Staff Report

REPORT NO.: DSD-2025-230

SUBJECT: Minor Variance Application A2025-051- 503 Victoria St. N.

Figure 2: Site Plan

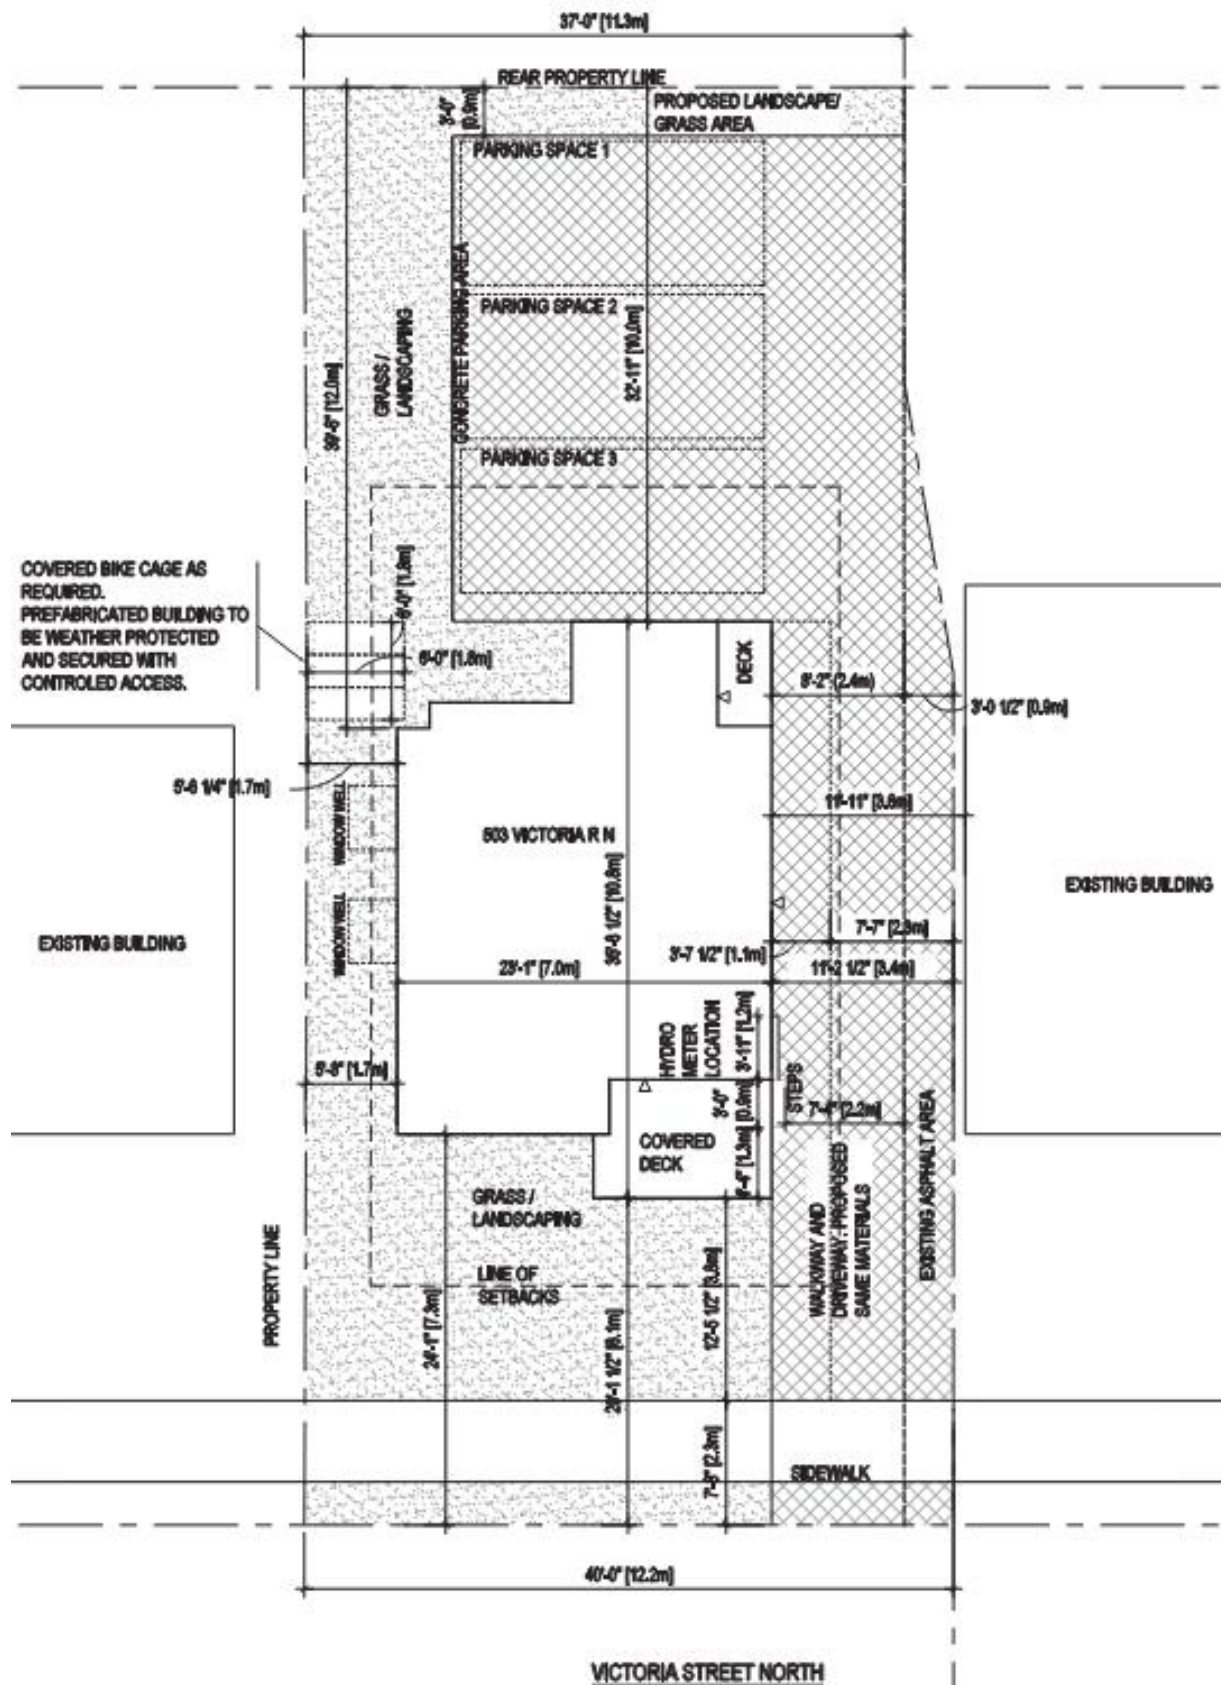
However, staff have significant concerns that the proposed variances to allow the Unobstructed Walkway to overlap entirely with the driveway will impede the appropriate functions of the land and potentially create adverse impacts on abutting properties, which conflicts with Official Plan policy 4.C.1.8.e). The applicant has stated that there is sufficient parking located within the rear yard and as such, the Unobstructed Walkway will only be temporarily obstructed when cars are entering and leaving the site. While it is true there are three (3) parking spaces located within the rear yard, Transportation Services has concerns with the functionality. As shown on Figure 11 below, the parking spaces are situated perpendicular to the house with about 8.5 metres of driveway width. After

In addition to Transportation Service's comments above, planning staff identified challenges with the existing parking layout during the site visit that further supports Transportation's concerns. As shown in Figures 6 and 7, the existing parking layout extends the entire length of the rear yard, which is proposed to be reduced to accommodate required rear yard landscaping. Despite this extra existing parking length, staff found it difficult to make the necessary turning movements to leave the site in either a forward motion or by reversing out of the parking space and driveway, leading staff to question whether the existing parking length could support three parking spots. This means that when the parking layout is reduced by 0.9 metres in length to meet the minimum rear yard landscaping requirements, the parking difficulties experienced by staff will only get worse and increase the chances of someone parking on the driveway beside the house directly within the path of the Unobstructed Walkway.

The general intent of the 1.1 metre wide Unobstructed Walkway comes from the Emergency Services Policy which requires a suitable emergency access route from a street or sidewalk to the principal entrance of an Additional Dwelling Unit (ADU) (Attached) where the door does not face a street. The Unobstructed Walkway must remain completely unobstructed at all times with at least 2.1 metres of overhead clearance to ensure timely emergency responses by guaranteeing that nothing will impede or block emergency equipment like stretchers or fire fighting equipment. As discussed above, staff anticipate that parking will occur on the driveway directly beside the house and within the Unobstructed Walkway due to the challenging rear yard parking layout and lack of on street parking. As such, Emergency Services are not satisfied that there is a suitable emergency access route.

Figure 9: Possible Shared Ground Floor Entrance

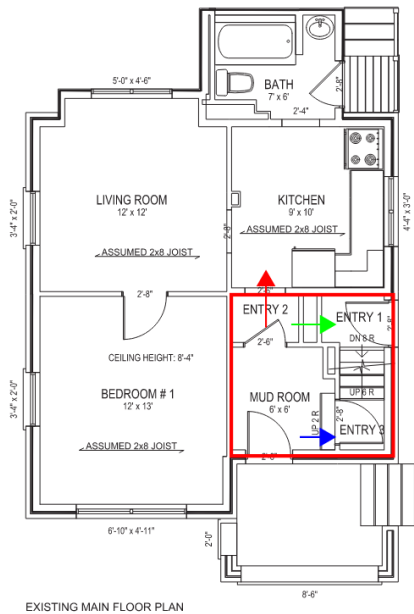
Staff note that it may be possible to avoid the variances to the Unobstructed Walkway and driveway material by modifying the existing shared entrance to include an entrance to the basement unit, as shown in Figure 9 below. This would facilitate the conversion of the existing 'Duplex' to a 'Triplex' while avoiding complications with the driveway overlapping with the Unobstructed Walkway.

Figure 11: Proposed Rear Yard Parking (Drive Aisle Measured using Plan Scale)

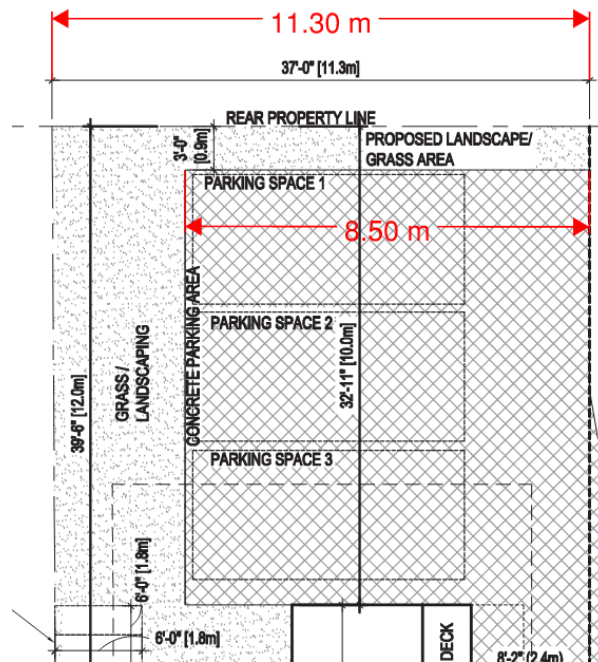
accounting for the minimum 5.5 metre parking spot there, there is only about 3 metres of space available to make the necessary 90 degree turn to enter and leave the parking space. This is significantly lower than the standard 6.7 metres drive aisle usually provided for turning movements for single loading parking. As such, Transportation Staff anticipate significant challenges with daily parking that may encourage or even force tenants to park on the driveway directly within the path of the Unobstructed Walkway.

- Based on the plan that was submitted with this application, Transportation Services cautions the applicant with the functionality of the existing parking. Accessing these parking spaces at the rear of the property will be difficult at times due to the narrow drive aisle. The plan notes in red an 8.5 metre parking length. This equates to a 3.0 metre drive aisle with a typical 5.5 metre parking space. Typically, a 6.7 metre drive aisle is provided for single loaded parking.
